Addendum Report

Modification of a Determined Review of Environmental Factors

Mitigation Works – Wilsons Beach, Abrahams Bosom Reserve Currarong

Figure 1. Location of the activity

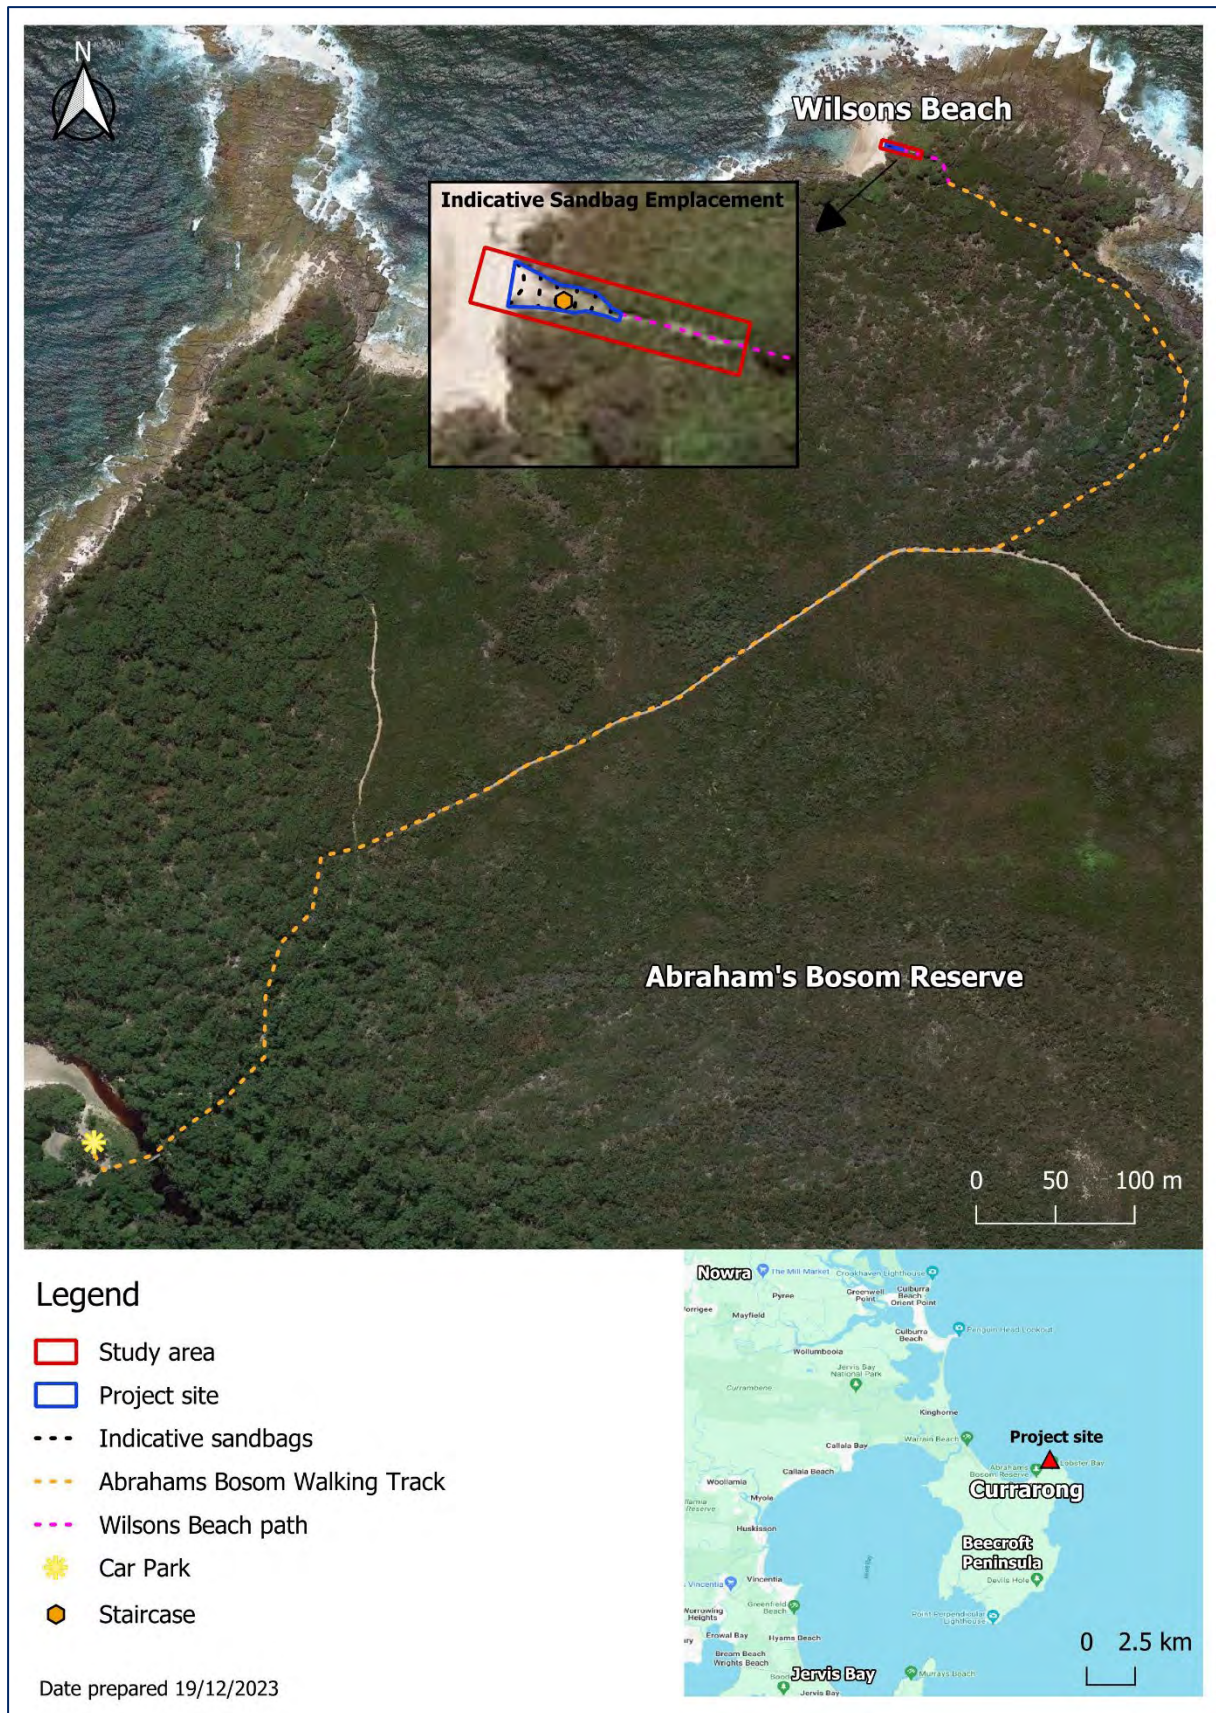
The proposed modification to the approved activity is the use of a small bobcat (skidsteer) and/or utility vehicle to deliver materials, personnel and so forth to site along the Abrahams Bosom Walking Track and Wilsons Beach access track, as opposed to

Abrahams Bosom Walking Track was included in the initial disturbance footprint for the proposal to permit pedestrian access only. The modification of an anticipated 150 trips by a small bobcat/utility vehicle along this to deliver materials to site requires assessment of potential impacts.

Reference to Figure 1 in the original REF (as reproduced as Figure 1 of this Addendum Report) notes the initial proposed work in the vicinity of Wilson Beach, and indicates the alignment of Abrahams Bosom Walking Track, as part of the original scope of work.

Figure 2. Vegetation mapping

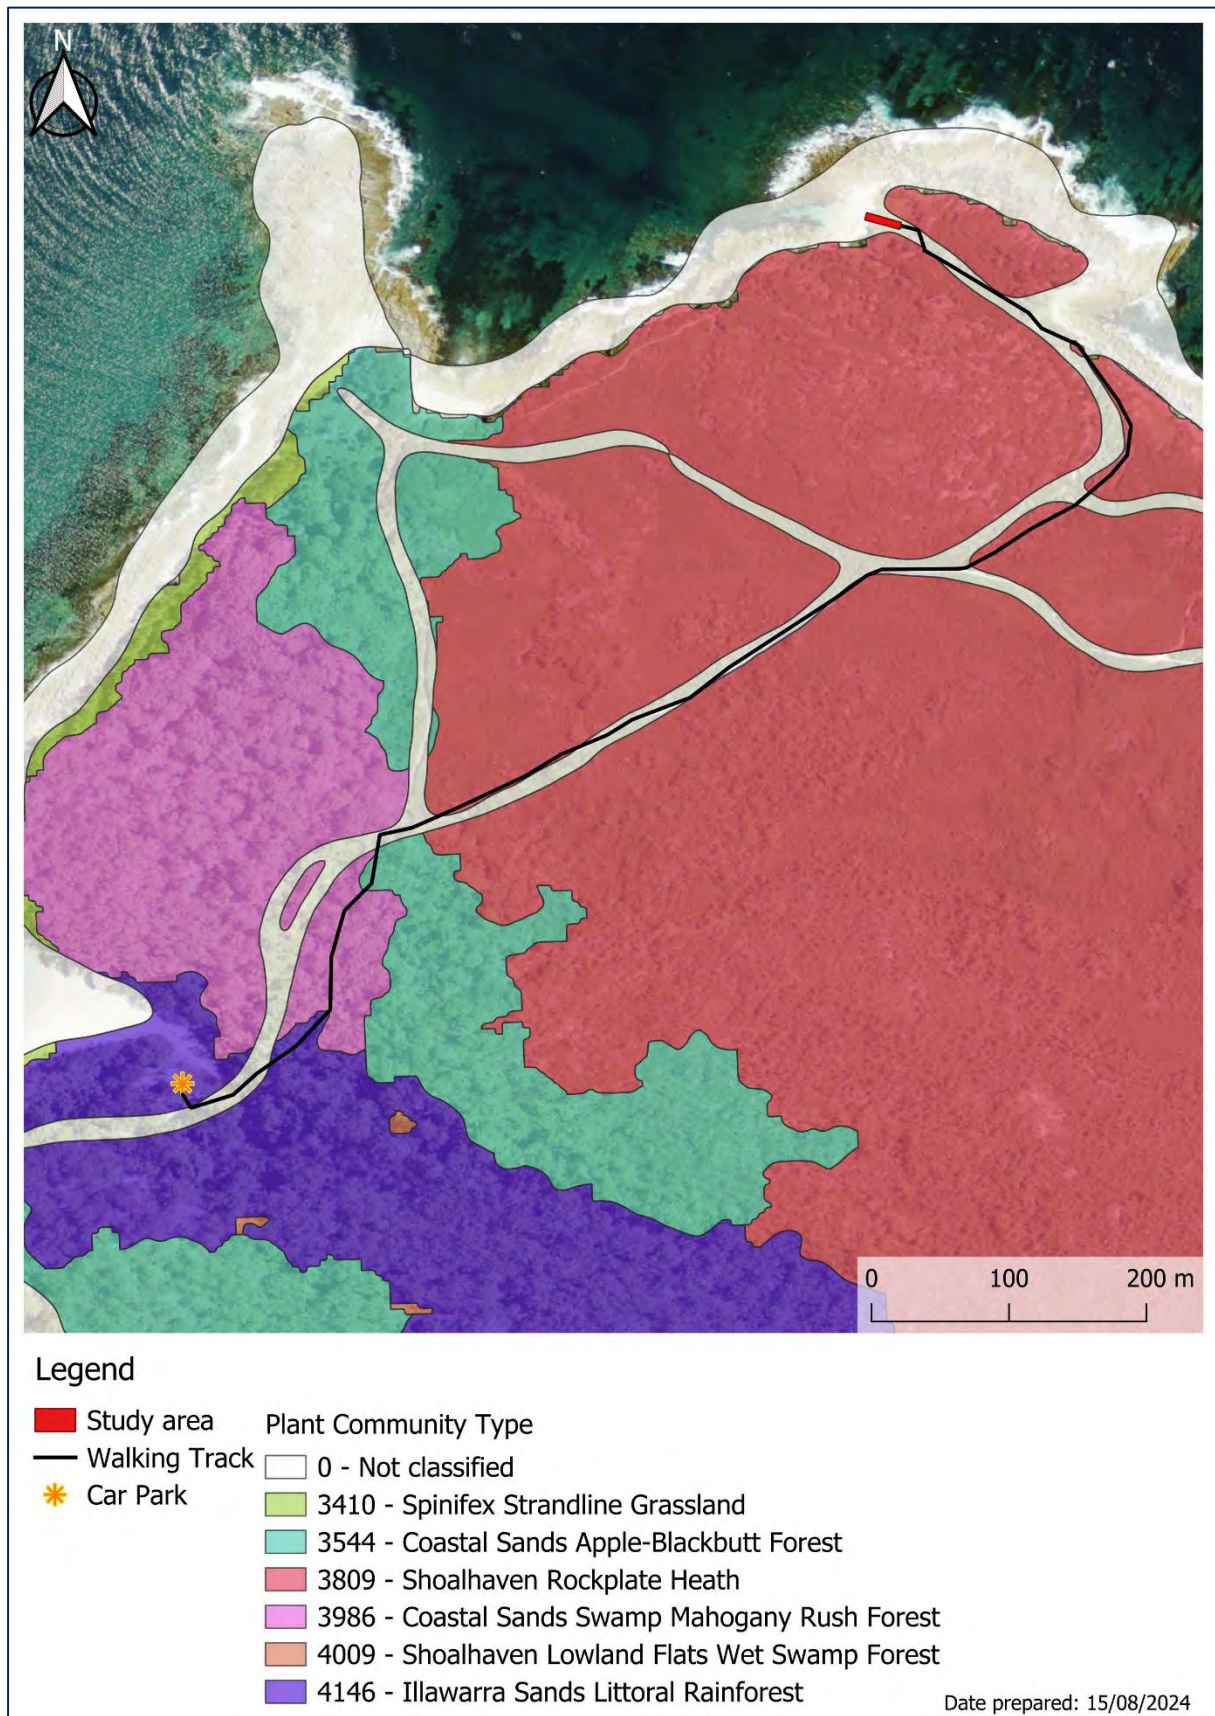
Section 6.6.1.2 of the original REF identified one mapped Plant Community Type (PCT) in the study area, being Shoalhaven Rockplate Heath (PCT 3809) with an existing distribution of 1509 ha. The original field survey confirmed that the vegetation mapping is accurate. Subsequent mapping with reference to the NSW State Vegetation Type Map (SVMT) (release C2.0M2.0) (State Government of NSW and NSW DCCEE 2023) identified the following additional PCTs along Abrahams Bosom Walking Track (Figure 2):

- Coastal Sands Apple-Blackbutt Forest (ID #3544)
- Coastal Sands Swamp Mahogany Rush Forest (ID #3986)
- Spinifex Strandline Grassland (ID #3410).

Of these, PCT 3986 conforms to the EPBC and BC Act listed threatened ecological communities (TEC); however, as determined in the original REF, as no vegetation removal is required to permit the proposal (including to permit access along the walking track), the proposed activity would have negligible impacts on the PCTs or TECs present.

Relevant to the proposal, Villous Mint-bush individuals were recorded in areas mapped as PCT 3544 – Coastal Sands Apple-Blackbutt Forest along the walking track.

- Prior to the commencement of the proposed work, at the location where the threatened Villous Mint-bush population was recorded along the Abrahams Bosom Walking Track, a botanist, or similarly qualified personnel who are familiar with the species, will temporarily demarcate the confirmed locations of this species with temporary fencing, bunting or similar and delineate a 'no-go' exclusion zone for construction, vehicles and/or personnel.
- Identify the Villous Mint-bush records on site maps/plans to be provided to the proposed works contractor.

- Personnel will keep to the existing, previously disturbed alignment of the Abrahams Bosom Walking Track, particularly when using the small bobcat/utility vehicle through the recorded location of the Villous Mint-bush plants [to be delineated] so as to not impact the threatened species.
